Plat Num: 20-058

Cumberland County Subdivision and Land Development Review Report

Municipality:	North Middleton	Surveyor/ Engineer:	Rettew	Owner/ Developer:	Keystone Arms Phase Two
Plat Title:	Keystone Arms – North Middleton				
Plat Status:	Final			Plat Type:	S Subdivision
# of New Lots:	4	# of New Dwelling Units:	0	New Acreage Subdivided/Developed:	6.76
Total Tract Acreage:	25.87				
Zoning District:	R-2			Proposed Land Use:	Residential
Date Received:	3/30/2020	County Review:	4/17/2020	Reviewed by:	EG
Checked by:

FINAL MAJOR LOT CONSOLODATION SUBDIVISION
FOR
KEYSTONE ARMS
NORTH MIDDLETON TOWNSHIP
CUMBERLAND COUNTY, PENNSYLVANIA

SUBDIVISION PLAN
FINAL MAJOR LOT CONSOLIDATION SUBDIVISION
FOR
KEYSTONE ARMS
NORTH MIDDLETON TOWNSHIP CUMBERLAND COUNTY, PA

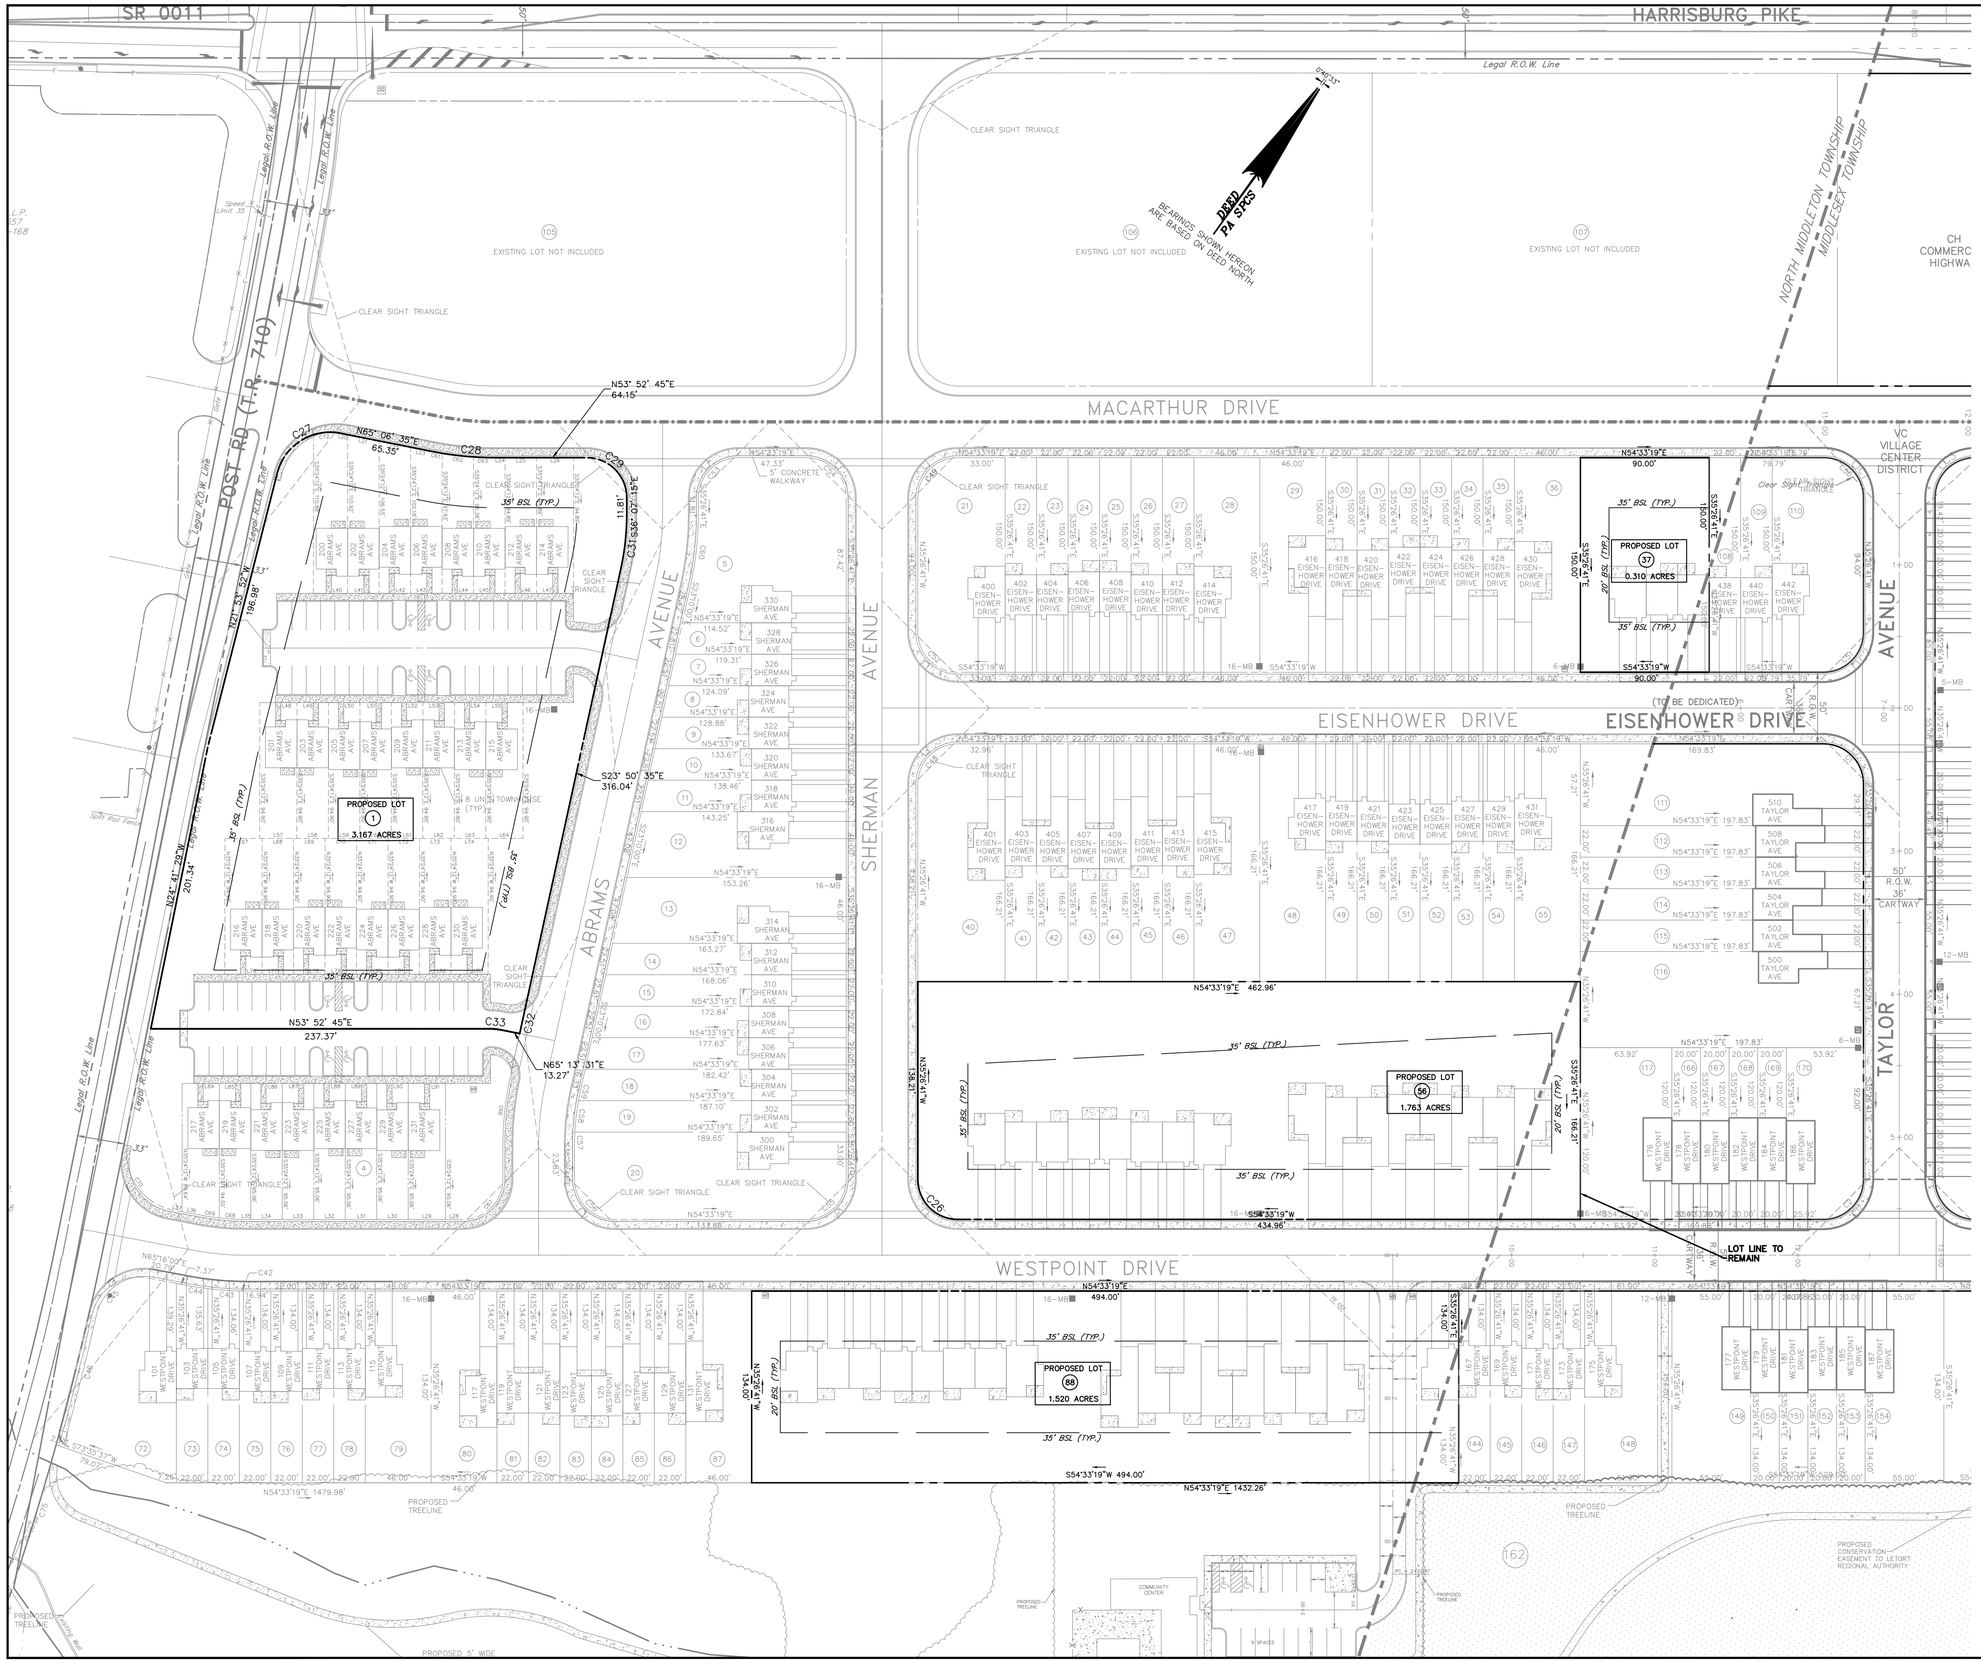
3. The township should determine if a waiver is required to review the plan submitted as a final plan. (SALDO 180-16)
4. Lots 5-20, 21-36, 40-55 and 71-87 appear to be in private ownership, and will not be affected by the proposed consolidation. Lot owner information for these lots should be included in the plan. (SALDO 180-24.B.7)

5. The Zoning Action described pertains to a Highway Commercial zoning change. The area or use affected by this zoning change should be indicated in the plan. (SALDO 180-24.B.13)

6. The zoning boundary to the north of MacArthur Drive should be labeled in the plan. (SALDO 180-24.B.13)
7. The township should verify the dwelling unit density in effect at the time of the original plan submission.
